Self Check Report. Stage: Before Casting Plinth Beam (Villas)

Block No	09	--	SL No.	
Company	SERENE CONSTRUCTION LLP	Project	Phase	
Prepared by	T. Sankarishan	Sign	Date	28/12/18
Project Manager	Sathya	Sign	Date	28/12/18
Previous stage report no.		Report filed and signed by PM?	<input type="checkbox"/> Yes <input type="checkbox"/> No	
Checked By M/D on		M/D Sign	For filing	<input type="checkbox"/> Yes <input type="checkbox"/> No

Villa NO - 8

Description	QC PLAN - VILLAS (1000 SFT)			Direction	N		
	COLUMN/PEDESTAL						
Owners & Developers :	Modi Properties Pvt Ltd.			Date :	01/03/18		
	Project Name & Phase : Serene Farms (Yenkappally)				Prepared By : Madhav Bhatt		
				Approved By :		Soham Modi	
				Scale :		N.T.S	
				Promoted by		Modi Properties Pvt. Ltd.	
				Phone: +91-40-66335551

Plinth Beam Steel check.

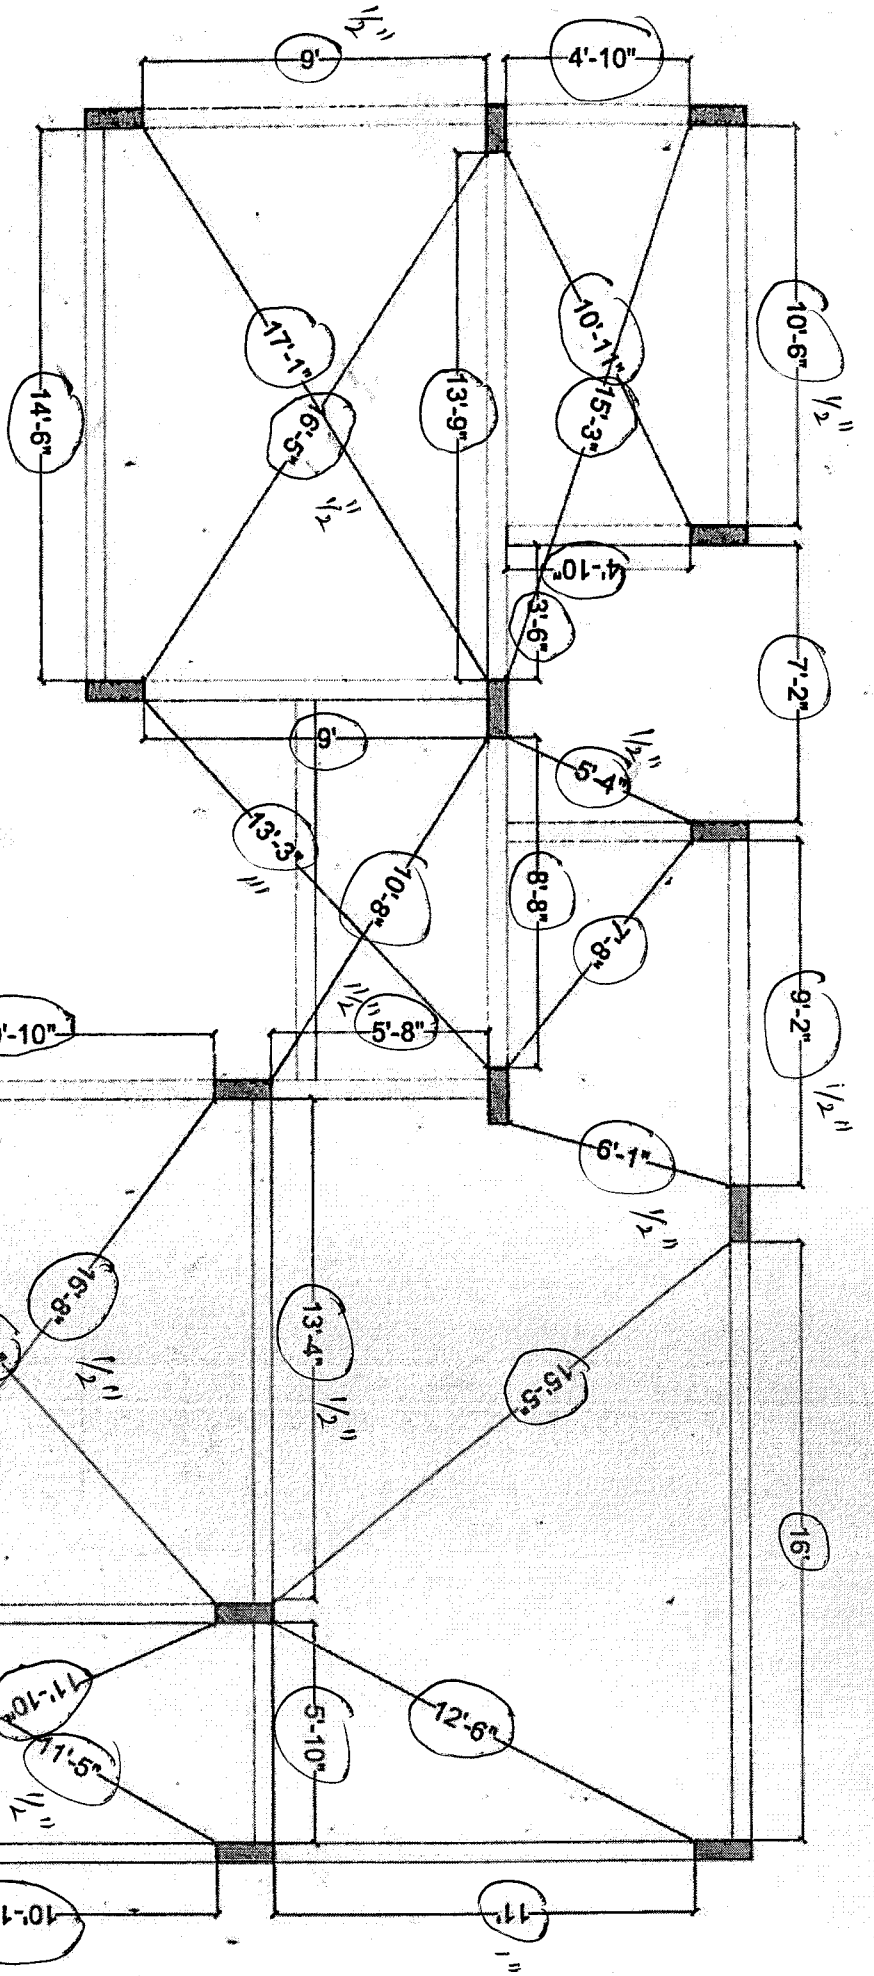
Column steel overlapping and cranking? (overlapping length should be 45 to 50 D)	<input checked="" type="checkbox"/> Correct <input type="checkbox"/> Needs correction
Remarks:	
Pedestal self check depth is attached.
